**City of Poughkeepsie
Historic District and Landmarks Preservation Commission
Meeting Agenda**

**RE: Pelton Mount Carmel
36 North Clover Street
Revised Submission**

Re: Project: Pelton Mount Carmel
36 North Clover Street
Re: Revised design of proposed development for HDLPC Approval

1 SITE SECTION
NTS

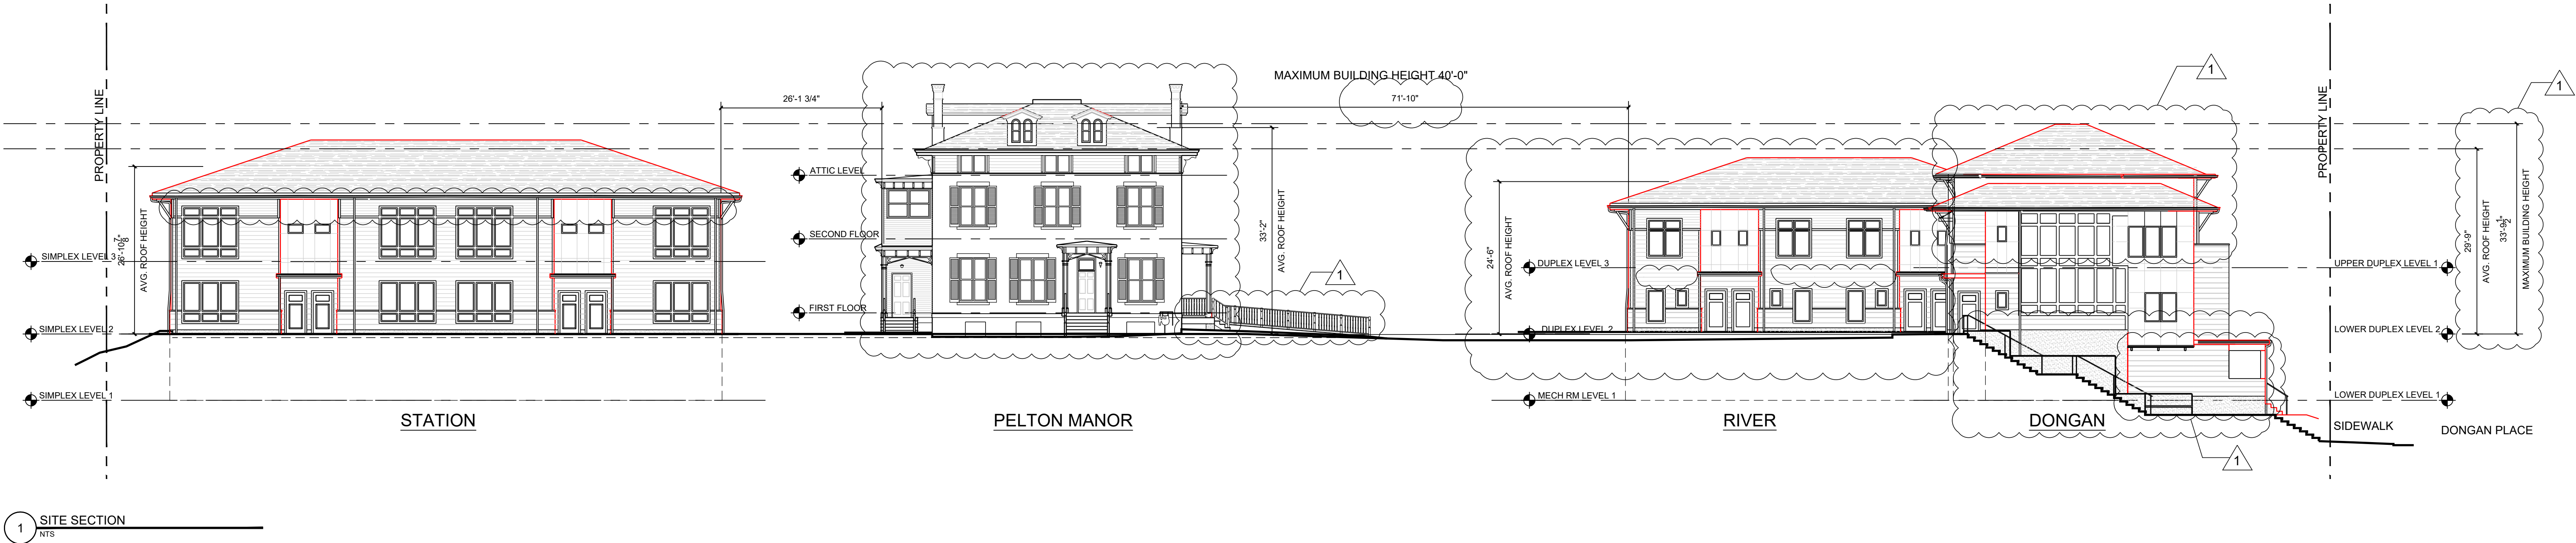
Sheet PZ-04 – Site Section:

1. A handicap ramp and additional sidewalk has been added to the north side of the Pelton Manor allowing for accessibility to the First Floor.
2. The lower portion of the east elevation of the Dongan Building has been adjusted to accommodate changes associated with the provision of the commercial space on Lower Duplex Level One. This includes the elimination of a small window on this level.
3. The upper portion of the east elevation shows the reduction in the ridge height of the 'Tower' form and the adjustment in the configuration of the roof line.

TRAFFIC CIRCULATION & SIGNAGE PLAN	
DRAWN BY: J.O.	PZ-25
JOB No. Y1022	
DATE: 7/5/17

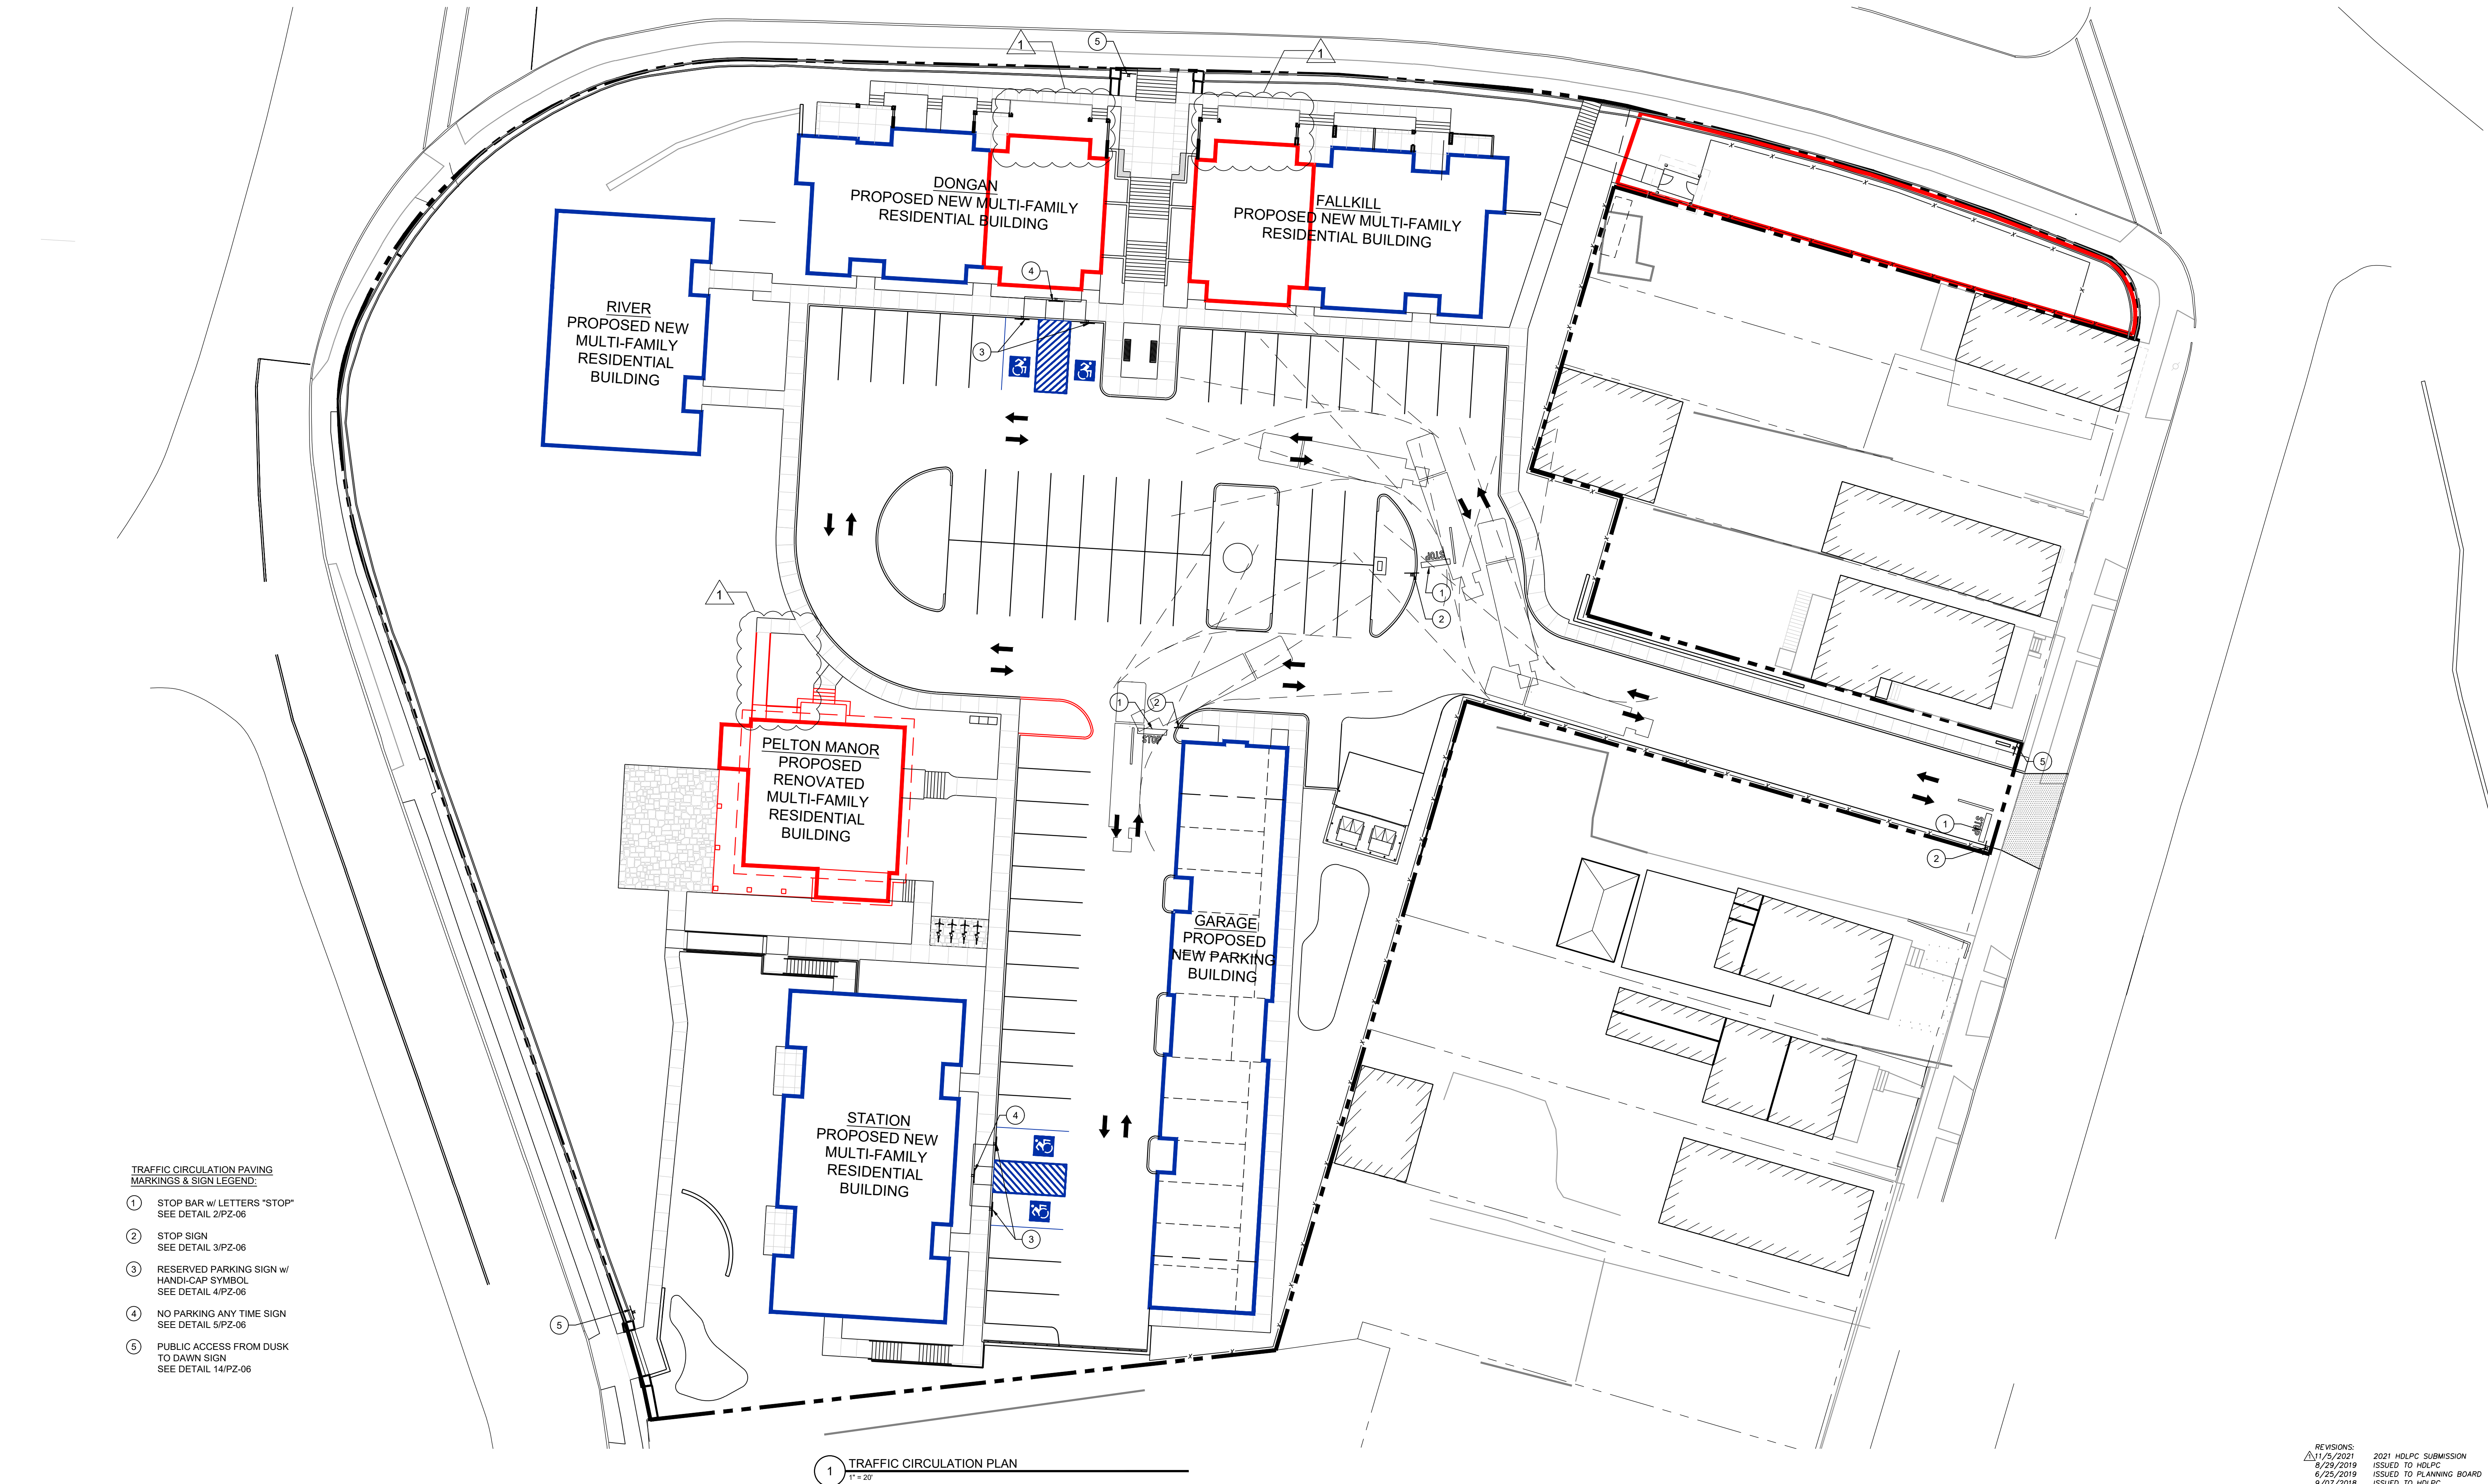
Sheet PZ-25 – Traffic Circulation & Signage Plan:
